Access Compliance Report

Public Rights-of-Way

Intersection ID: 15466	Main Street: CHARLOTTE_DR	Cross Street: LEDGEWOOD_LN	Location: NE
ADA ID: D6719D271F5B	Ramp Type: PerpDiag	Initial Pass/Fail: Pass	Overall Compliance: No
		Severity Score: 20

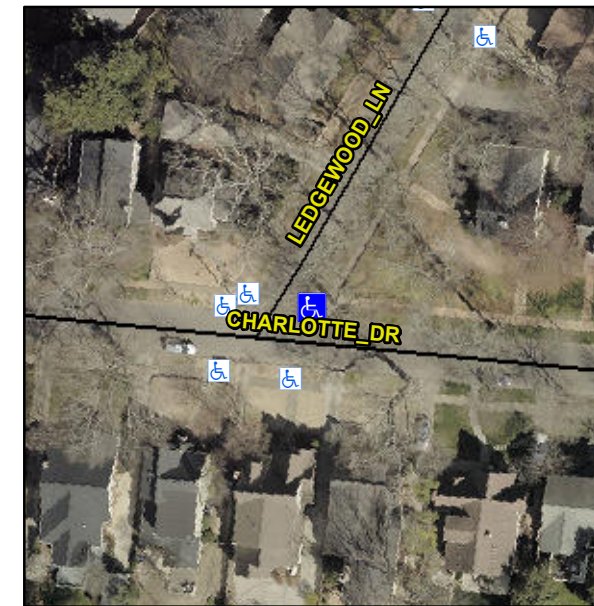
R304.2.1, R304.2.2-Perp, R304.3.2-Para, R304.2.3, R305.2, R302.7, R302.7.2, R304.5.3

Compliance	Description	Data	Compliance	Description	Data
N/A	Ramp Length (in)	112.0	Yes	Ramp Slope (%)	7.7
Yes	Ramp Width (in)	48.0	Yes	Ramp XSlope (%)	0.6
N/A	Flare Type LT	Sloped	N/A	Flare Type RT	N/A
N/A	Flare Slope LT (%)	13.3	Yes	Flare Slope RT (%)	9.6
N/A	Flare Traversable LT?	Yes	N/A	Flare Traversable RT?	Yes
No	Landing Length (in)	48.0	Yes	DWS Provided?	Yes
Yes	Landing Width (in)	48.0	Yes	DWS Contrast?	Yes
No	Landing Slope (%)	3.1	Yes	DWS Length (in)	24.5
Yes	Landing X Slope (%)	0.1	Yes	DWS Full Width?	Yes
N/A	Landing Curb? (Y/N)	Yes	No	DWS Offset (in)	3.5
N/A	Shared Landing?	No			
No	Gutter Ponding?	Yes	Yes	Gutter Slope (%)	0.4
No	Gutter Lip Ht (in)	1.5	No	Gutter X Slope (%)	3.4
N/A	Painted X Walk1?	No	N/A	Painted X Walk2?	No
	X Walk 1 Direction	To NW		X Walk 2 Direction	To SW
N/A	X Walk 1 Width (in)	N/A	N/A	X Walk 2 Width (in)	N/A
	X Walk 1 Slope (%)	3.1		X Walk 2 Slope (%)	3.7
	X Walk 1 X Slope (%)	3.1		X Walk 2 X Slope (%)	0.9

Remove & Replace Curb Ramp With Two New Directional Ramps or Equivalent. Remove & Replace Gutter.
